Project	IEEE 802.16 Broadband Wireless Access Working Group < http://ieee802.org/16 >	
Title	Unique Randomizer Initialization for Interference Management in 802.16 OFDM PHY	
Date Submitted	2004-03-16	
Source(s)	Adam Kerr, Paul Petrus ArrayComm, 2480 North First St. San Jose, CA 95131-1014	Voice: 408-428-9080 Fax: 408-428-9083 E-mail: adam@, petrus@arraycomm.com E-mail: hassan.yaghoobi@intel.com
	Hassan Yaghoobi Intel Corporation	
Re:	IEEE 802.16-REVd/D3-2004	
Abstract	Describes changes to initialization vector for randomizer in OFDM-256 PHY.	
Purpose	These changes will provide for improved detection of error at the PHY level in low reuse networks.	
Notice	This document has been prepared to assist IEEE 802.16. It is offered as a basis for discussion and is not binding on the contributing individual(s) or organization(s). The material in this document is subject to change in form and content after further study. The contributor(s) reserve(s) the right to add, amend or withdraw material contained herein.

Unique Randomizer Initialization for Interference Management in 802.16d OFDM PHY

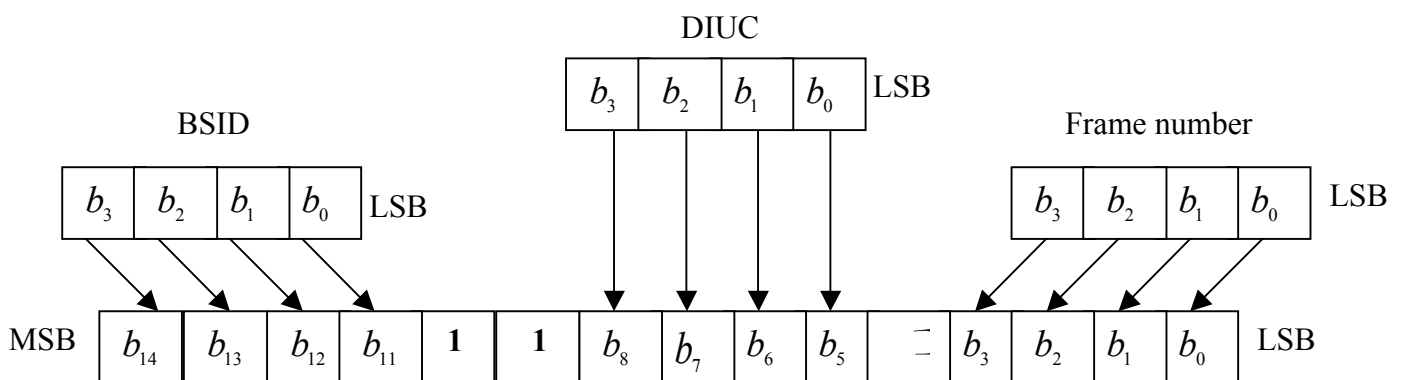
In order to create a randomization that is dependent on both base station and the connection, we introduce modifications to this seed value. For the preambles and broadcast portion of the downlink frame (FCH and burst #1) we recommend maintaining the fixed constant seed value as currently defined. For all other downlink bursts and all uplink bursts, we recommend that a combination of base station ID, DIUC/UIUC and frame number form the seed value for the shift register, rather than the current combination of DIUC/UIUC and symbol number.

The base station ID is a 48-bit value with the upper 24 bits being the operator ID, and the lower 24 bits used to identify the base station, while the frame number is 24 bits long. We recommend that the new randomizer seed values be formed from the lowest 4 bits of the base station ID, 4 bits of DIUC/UIUC and the lowest 4 bits of frame number.

OFDM Scrambler Initialization Vector

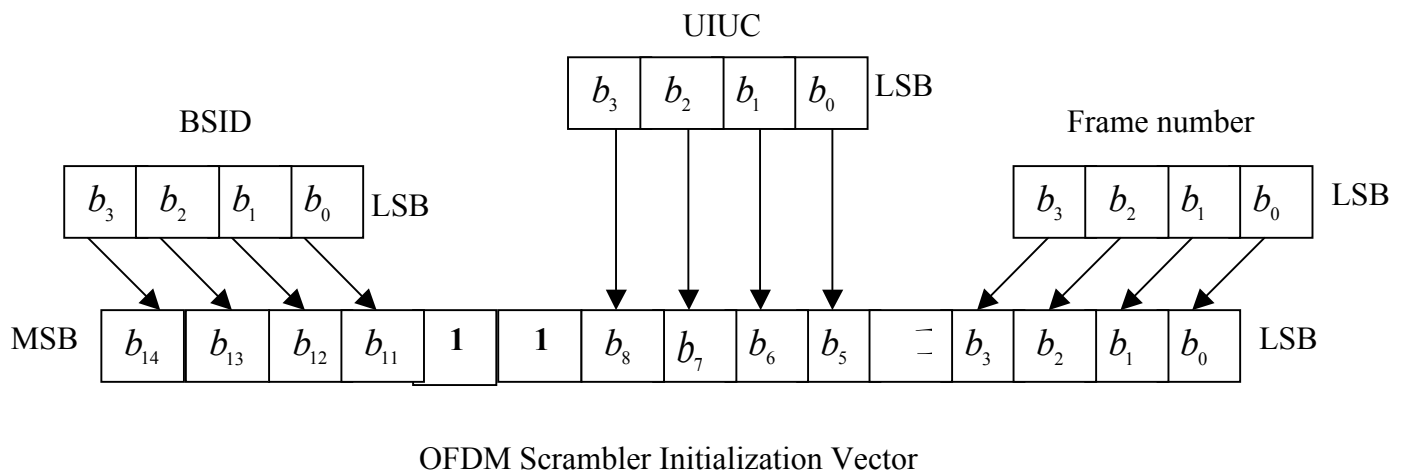
1) The paragraph immediately above Figure 192 is changed to read:
 “On the downlink, the randomizer shall be re-initialized at the start of each frame with the vector: 1 0 0 1 0 1 0 1 0 0 0 0 0 0. The randomizer shall not be reset at the start of burst #1. At the start of subsequent bursts, the vector shown in Figure 192 shall be used to initialize the randomizer. ~~The OFDM symbol number (i.e. the number of the first OFDM symbol of the data burst) shall be counted from the start of the DL subframe, the first symbol being counted as symbol #0.~~”

3) Figure 192 is replaced with:
